**SUBJECT:** Propeller Installation Mounting Torque

MODELS AFFECTED: All McCauley Propellers

Service Bulletin 227B replaces Service Bulletin 227A dated September 21, 1998. Service Bulletin 227B adds the Orenda engines and specific torque for C524 propeller. Lines in margin indicate changes.

# Figure 1. Decals

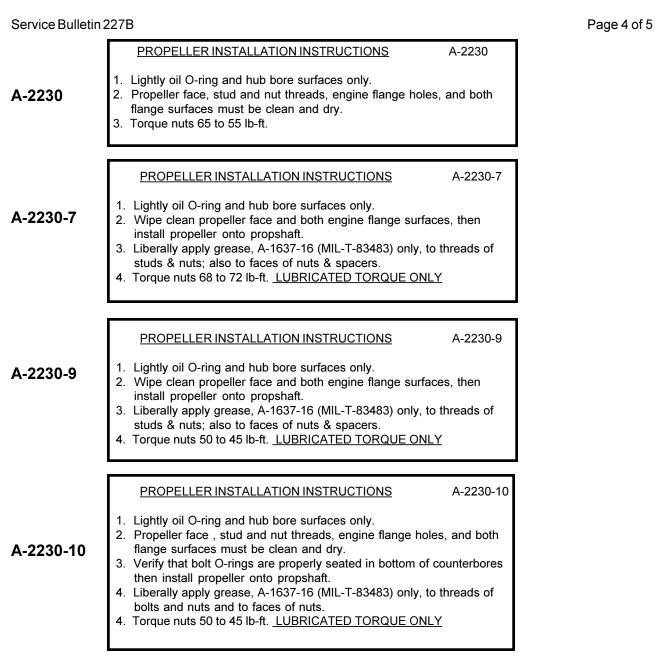
Style 1: Hubs were manufactured in which the bolts extend through the hub wall. These hubs have a counterbore where each bolt protrudes through the hub. O-rings are installed in the counterbore prior to propeller installation. Propellers with this style hub use the A-2230-10 decal (Figure 1).

Style 2: Hubs are now manufactured with studs threaded directly into the hub wall mounting surface. Propellers with this style hub use the A-2230-9 decal (Figure 1).

Style 3: 3FF32C501 propeller models only use A-2230-7 decal (Figure 1).

All propellers installed on Franklin engines use lubrication on the mounting hardware at installation. These propellers use the A-2230-9 decal (Figure 1).

All propellers installed on Lycoming engines use <u>no</u> lubrication on the mounting hardware. This installation uses a dry torque value. These propellers use the A-2230 decal (Figure 1).

3AF32C524 propeller models only use A-2230-9 decal (Figure 1). The D-7548/C524 is a Continental hub used on a Lycoming engine. The Lycoming GO-480 engine has a Continental engine flange.

All propellers installed on Garrett or Pratt-Whitney engines are to be installed with lubrication on mounting hardware. These propellers use the A-2230-7 decal (Figure 1).

All propellers installed on Orenda engines are to be installed with lubrication on mounting hardware. These propellers use the A-2230-7 decal (Figure 1).
